ORIGINATION FORM

Proposed Revisions to a Standard Plans Index
(Please provide all information – Incomplete forms will be returned)

Index Number: **635-001**
Sheet Number (s): Pull and Splice Boxes
Index Title: 1 of 1

Summary of the changes:

LAST REVISION 11/01/17	DESCRIPTION:	 FY 2018-19 STANDARD PLANS	PULL AND SPLICE BOX	INDEX 635-001	SHEET 1 of 1
---------------------------	--------------	----------------------------------	----------------------------	------------------	-----------------

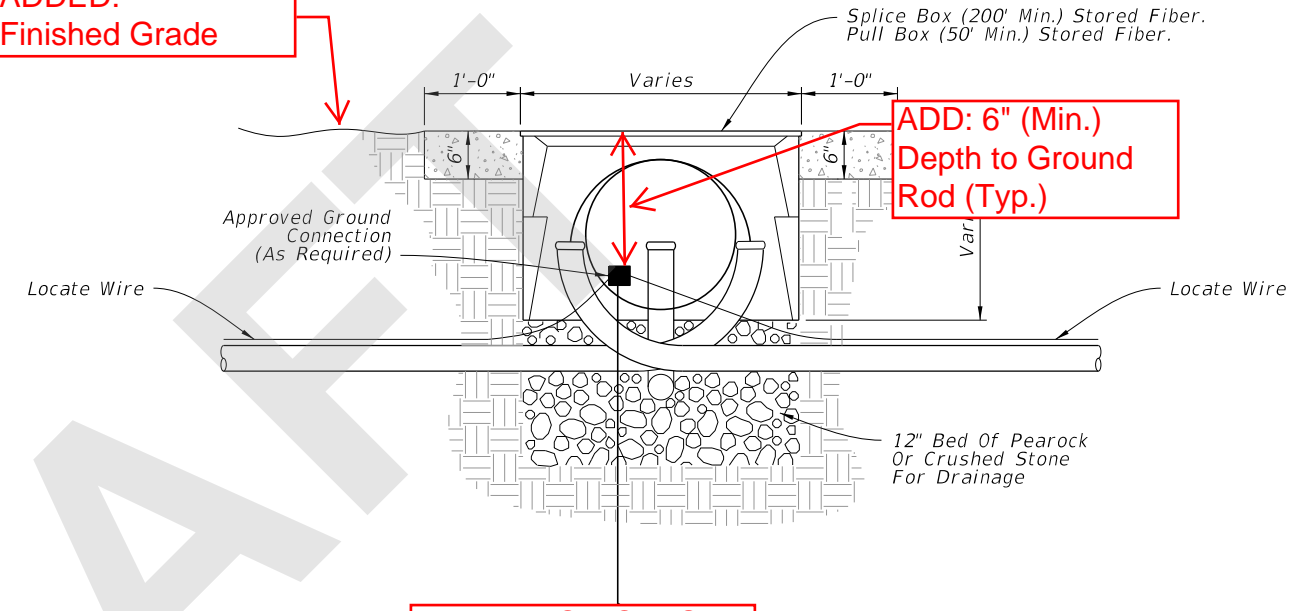
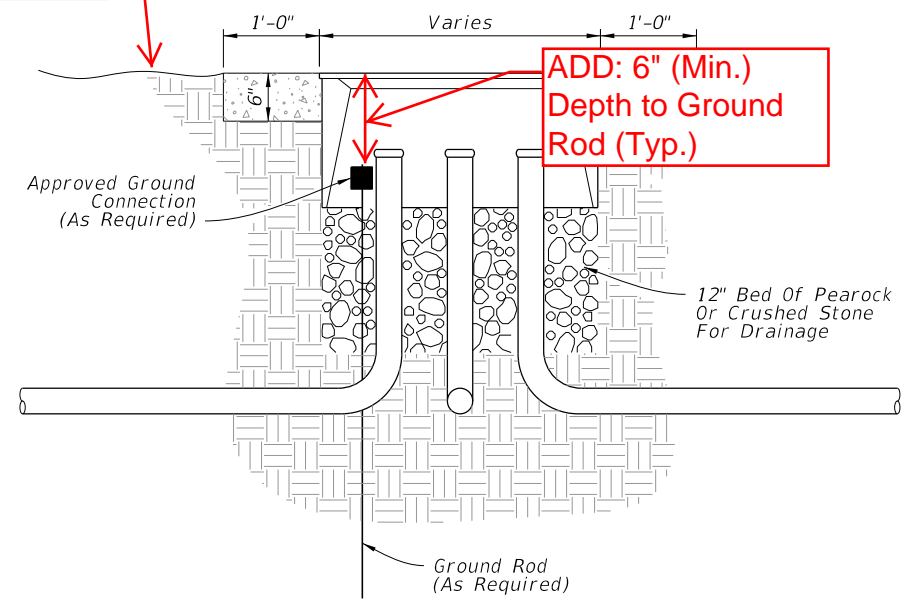
Updated Notes; Added 6" Min. Depth to Ground Rod from top of Pull and Fiber Optic Boxes.

ADDED:
Finished Grade

ADDED:
Finished Grade

UPDATED NOTES

7. All boxes shall have 1'-0" wide (Min.) concrete apron. Concrete for concrete aprons shall be Class NS with a minimum strength at 28 days of f'c=2.5 Ksi. Aprons shall be sloped away from box. Cost of apron to be included in the cost of each box.
8. Prevent the ingress of Water, Dirt, Sand, and other foreign materials into the conduit prior to, during and after construction using a foam-sealing material, rubber plug, or other device designed for this application.
9. Where multiple pull boxes are placed side by side, maintain at least 8" between the pull boxes.
